COUNCIL ASSESSMENT REPORT

Panel Reference	PPSSCC-338
DA Number	DA 1112/2022/JP
LGA	The Hills Shire Council
Proposed Development	Demolition of Existing Structures and Construction of a Residential Flat Building Development with a ground level neighbourhood shop containing 255 units.
Street Address	7-23 Cadman Crescent & 18-24 Hughes Avenue Castle Hill
Applicant	Castle Hill Panorama
Consultant/s	Mecone (Planner) MHNDU (Architects and Design Verification) Turf Design Studio (Landscape Architects) Survplan (Survey) Inroads Group (Traffic) Earthscape (Arborist) Douglas Partners (Site Investigation) Neuron Build (Services) Northrop (Civil and Stormwater and Acoustic) EI Australia (Geotechnical and Detailed Site Investigation) Credwell (Access and BCA) Elephant's Foot (Waste Management) CBRE (Land Valuation)
Date of DA lodgement	25 January 2022
Number of Submissions	Nil
Recommendation	Refusal
Regional Development Criteria - Part 2.4 and Schedule 6 of the SEPP (Planning Systems) 2021	CIV exceeding \$30 million (\$85,490,156 excluding GST) and the development

Summary of key submissions	N/A
Report prepared by	Cynthia Dugan – Principal Coordinator Development Assessment
Report date	24 June

d) Height

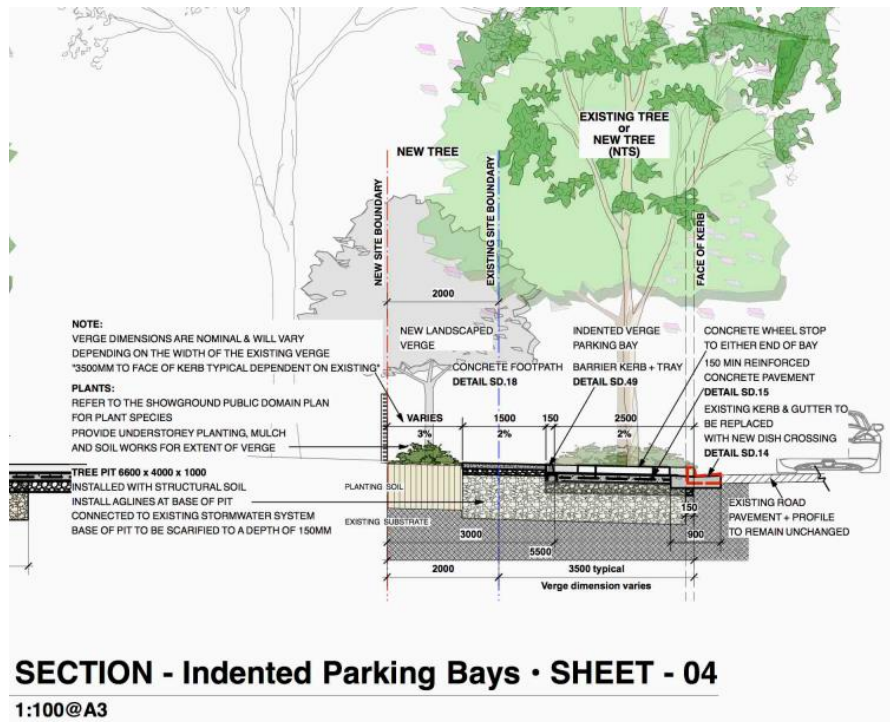
The approved concept Development Application was supported with a maximum variation to the height standard by up to 2.85m (13.57%). The Clause 4.6 written submission to vary standard was supported as the Applicant's request was considered to be well founded; the proposed variation result in a development that is consistent with the objectives of Clause 4.3 Height of Building, and the R4 High Density zone objectives; compliance with the standard is unnecessary in this instance and there are sufficient environmental grounds to justify the contravention; and the proposed development will be in the public interest.

The proposal seeks a further exceedance to the height standard which is inconsistent with the approved Concept Development Application. Refer Section 3c(i) for more detailed discussion regarding the merits of the Clause 4.6 for the subject application.

The Showground Precinct – Verge Treatment Details are identified below:

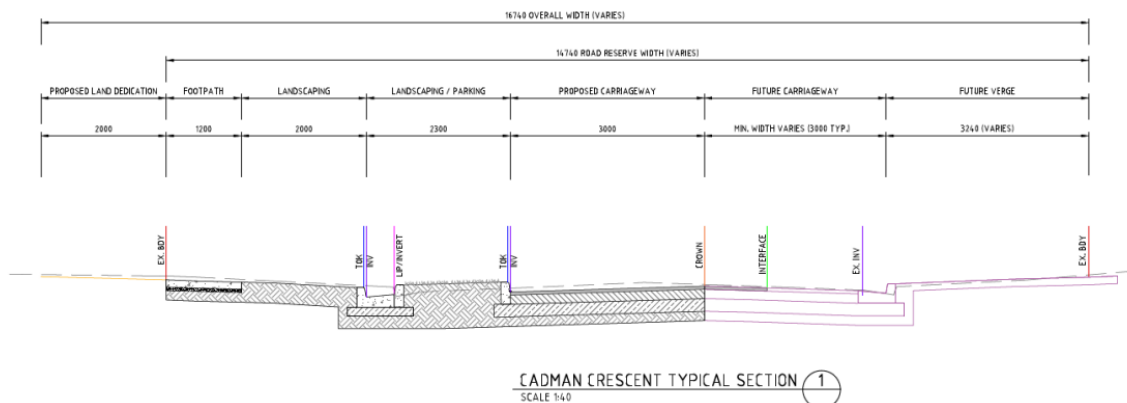
The subject application seeks to vary the typical cross sections as shown in the DCP and the Showground Precinct – Verge Treatment Details as follows:

A subdivision works concept plan relating to the indented parking bays and associated public domain works has not been submitted with the built form application.

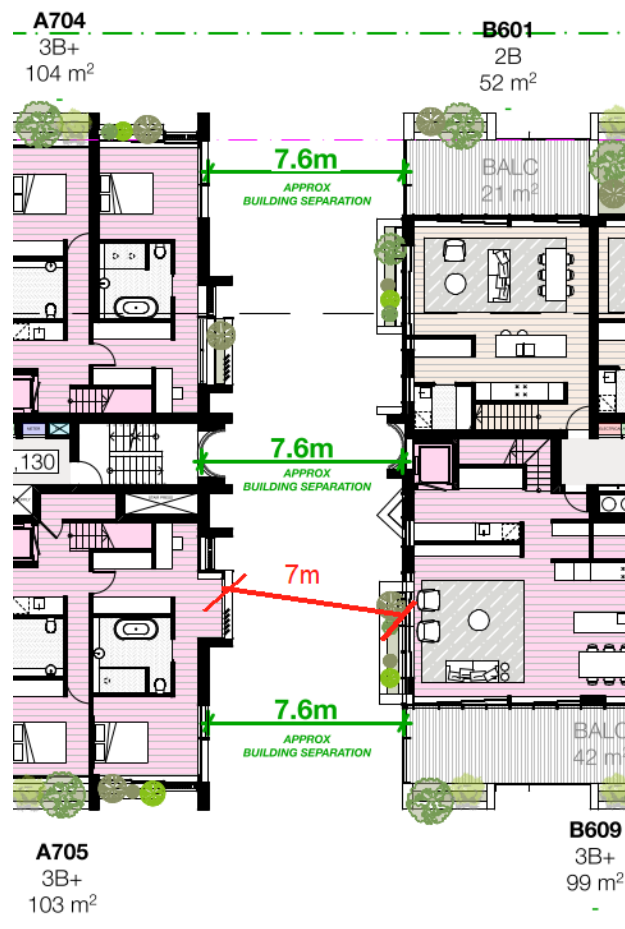
- Levels 1 to 4 - Minimum 7m (habitable to habitable where 12m is required)
- Levels 5 to 8 - Minimum 7m (habitable to habitable where 18m is required).

A 6m side setback is provided to the adjoining properties to the west of the site, to enable adequate separation, visual privacy and ADG compliance should these sites be developed in future. Within the site, the separation distances between buildings are outlined in Part 2F of this table. Visual and acoustic privacy is achieved between buildings, via the following design responses:

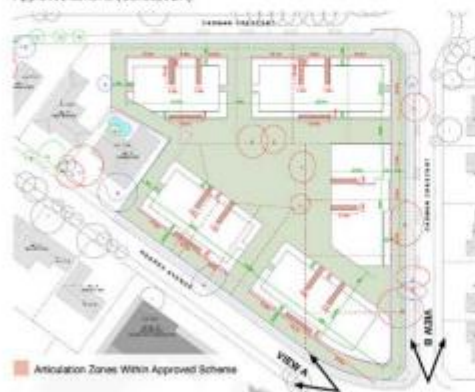
The street interface to Hughes Street is not conducive to good design and can be improved by redesigning the elevation and creating an activated street address and fine grain articulation to apartments of building E and reducing the height and length of the 2m high wall.

The four apartments on the south part of building D above the carpark can't be accessed directly from Hughes Ave due to safety and change of levels. Alternative access is provided around the corner via the prominent site entrance.

Figure 6: Diversity - p.49

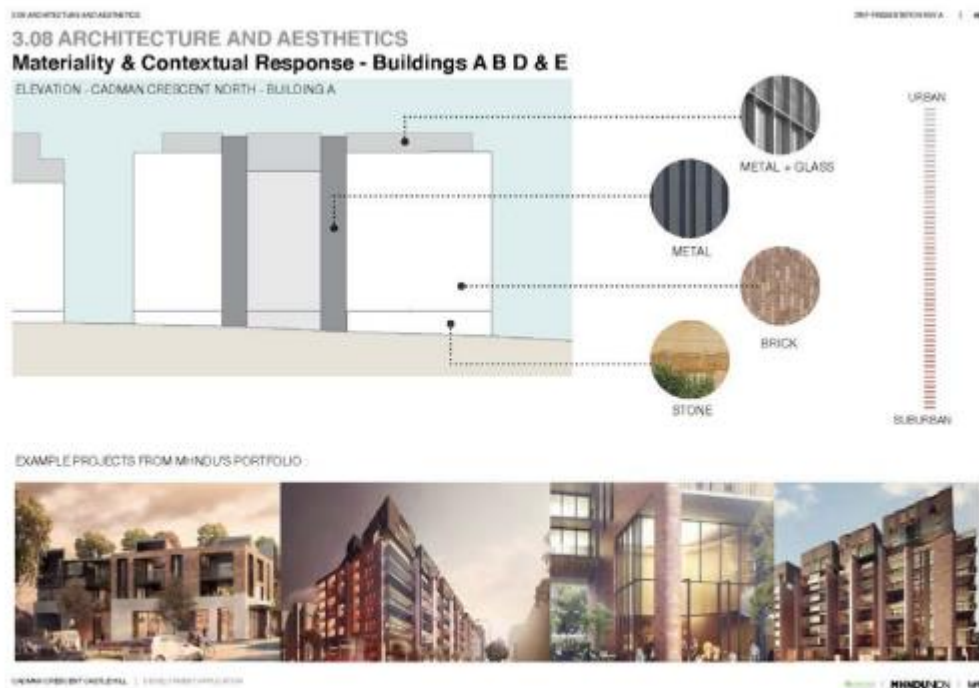
The prominence of the two lift cores on the roof of Building C contradicts the urban design strategy to underscore the impact of the two new levels from the public domain. While being important architectural elements, the lift overruns increase the bulk and scale of Building C when viewed from the public domain. The relocation of the lifts in the recesses closer to the central courtyard (similar to Buildings A and B) or use of a transit lobby would be more compatible with the broader design intent.
